EPRI Technical Report 3002025288 “Enhanced Risk-Informed Categorization Methodology for Pressure Boundary Components”

NRC Public Meeting

April 30, 2024

Supplemental Item 1 – Example 1

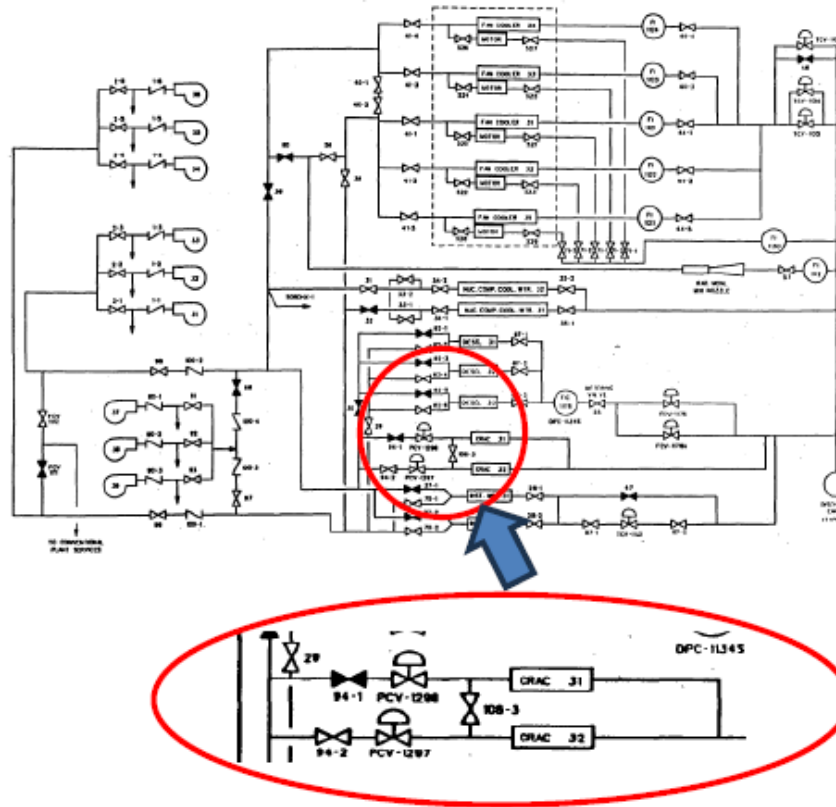
Concern:

A single rupture of either line in each Crescent Area has the potential to result in flood and spray damage to a core spray pump, LPCI/RHR pump on one loop, and either HPCI or RCIC pump controls. Damage to the pumps is risk significant.

EPRI TR 3002025288:

This could be categorized as LSS since it falls outside the scope of Criterion 7 which only addresses failures associated with the CST for PWRs as HSS.

Supplemental Item 1 – Example 2

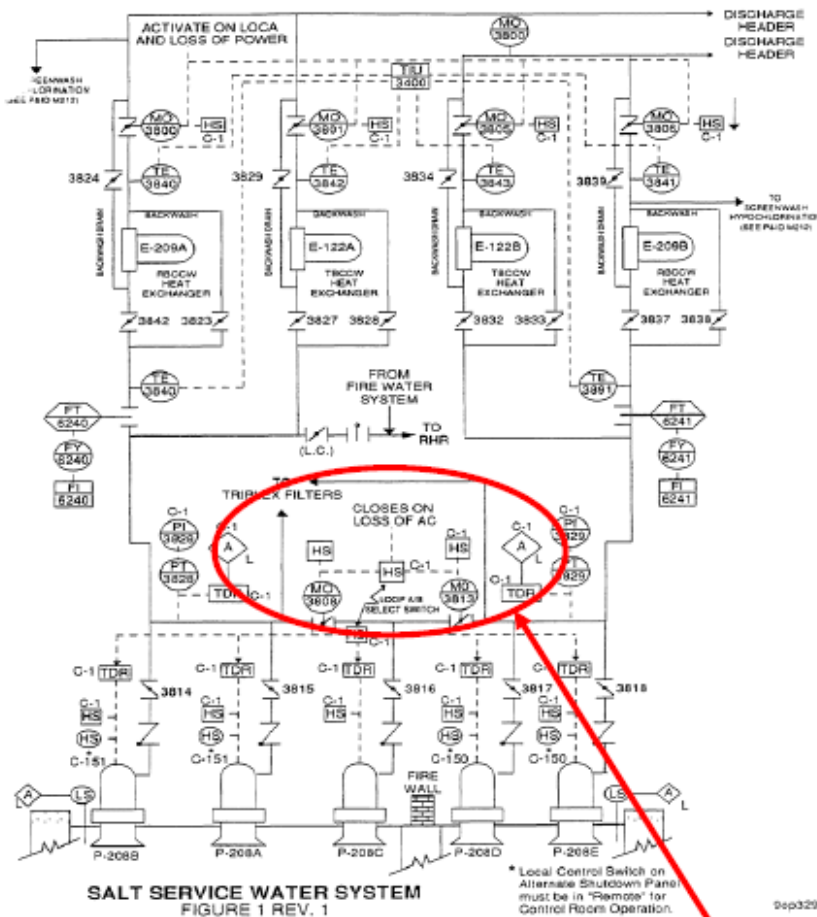
Concern:

A single rupture could pose a control room habitability issue since both CRAC units are impacted and radiological calculations at this plant has computed a post-accident source term in the Turbine Hall outside the control room doors. Damage to the pumps is risk significant.

EPRI TR 3002025288:

The staff is concerned that this would be categorized as LSS, per the EPRI proposed methodology, because the conditions of Criteria 1-10 may not be met. And, since control room HVAC is not modeled in most licensee model-of-records, there is no entry into Criteria 11-13 as a safety-net to determine as HSS.
